REVISED RESPONSE TO REQUEST FOR ADDITIONAL INFORMATION

APR1400 Design Certification
Korea Electric Power Corporation / Korea Hydro & Nuclear Power Co., LTD
Docket No. 52-046

RAI No.: 222-8203
SRP Section: 11.05 – Process and Effluent Radiological Monitoring Instrumentation and Sampling Systems
Application Section: 11.5
Date of RAI Issued: 09/23/2015

Question No. 11.05-3

Figure 11.5-3C Monitor Assembly for Main Steam Line Effluent + N-16 Detectors

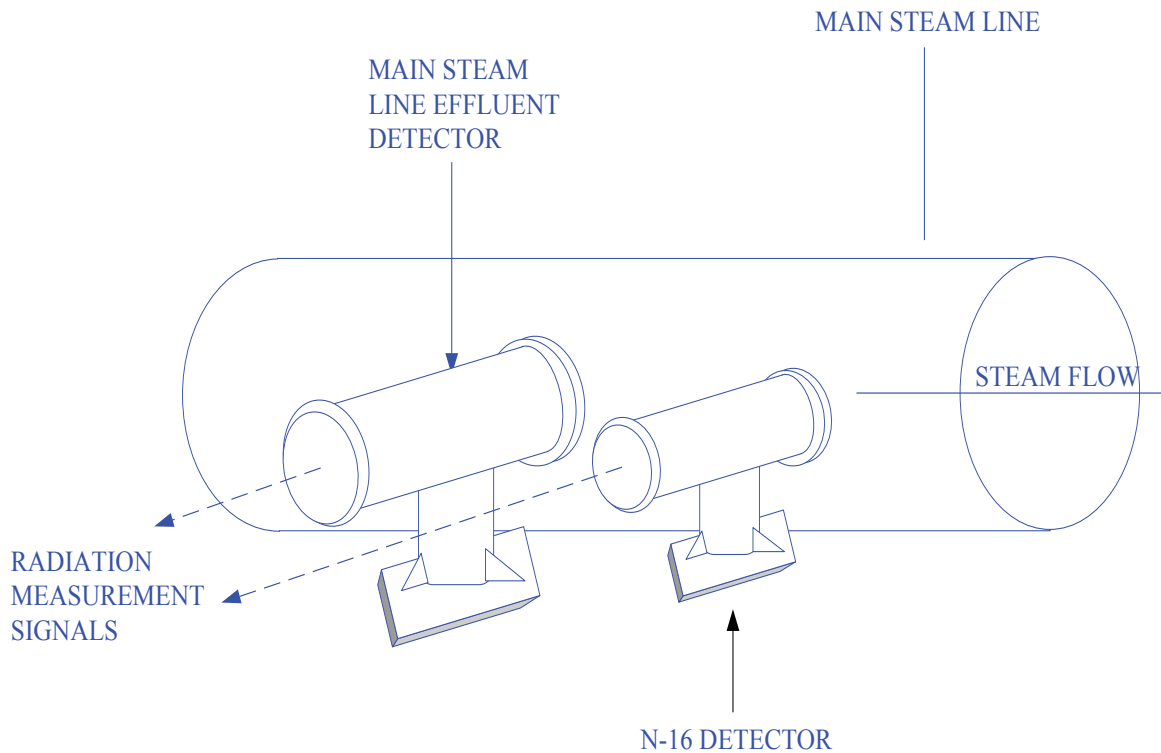
Because the reactor coolant system (RCS) is a safety-related system, steam generator (SG) tube integrity is a safety-related issue. 10 CFR 52.47(b)(1) requires that a DC application contain the proposed ITAAC that are necessary and sufficient to provide reasonable assurance that, if the inspections, tests, and analyses are performed and the acceptance criteria met, that a plant that incorporates the design certification is built and will operate in accordance with the design certification and the provisions of the Atomic Energy Act, and NRC regulations. The applicant has not provided adequate Tier 1 ITAAC information to verify the compliance with the design criteria.

The ITAAC should address the sensitivity, response time, and alarm limit for the SG Tube leakage detection instrumentation. The staff requests the applicant to provide ITAAC for this system in the DCD Tier 1.

Please address this item and provide a markup for the proposed DCD changes.

This is required by RG 1.97 Rev.3 and the RMS purchase specifications require the supplier comply with this requirement. Please refer to DCD Tier 2, Subsection 11.5.2.2.5.m and Figure 11.5-3C.

One monitor on each of the four main steam lines is provided in the main steam line support structure. The monitors are placed as close as possible to the pipe as shown in Figure 11.5-3C, upstream of the main steam atmospheric dump valves and main steam safety valves.

1. The main steam line (MSL) effluent monitor detects the radioactive effluent discharge through MSSV's, MSADV and AUX feedwater pump exhaust. This detector performs the function required by NRC RG 1.97.
2. The N-16 detector senses the SG tube leak.
3. Depending on the supplier, the two detectors (MSL and N-16) is assembled as one unit or the two are mounted as two separate but adjacent unit as shown above.
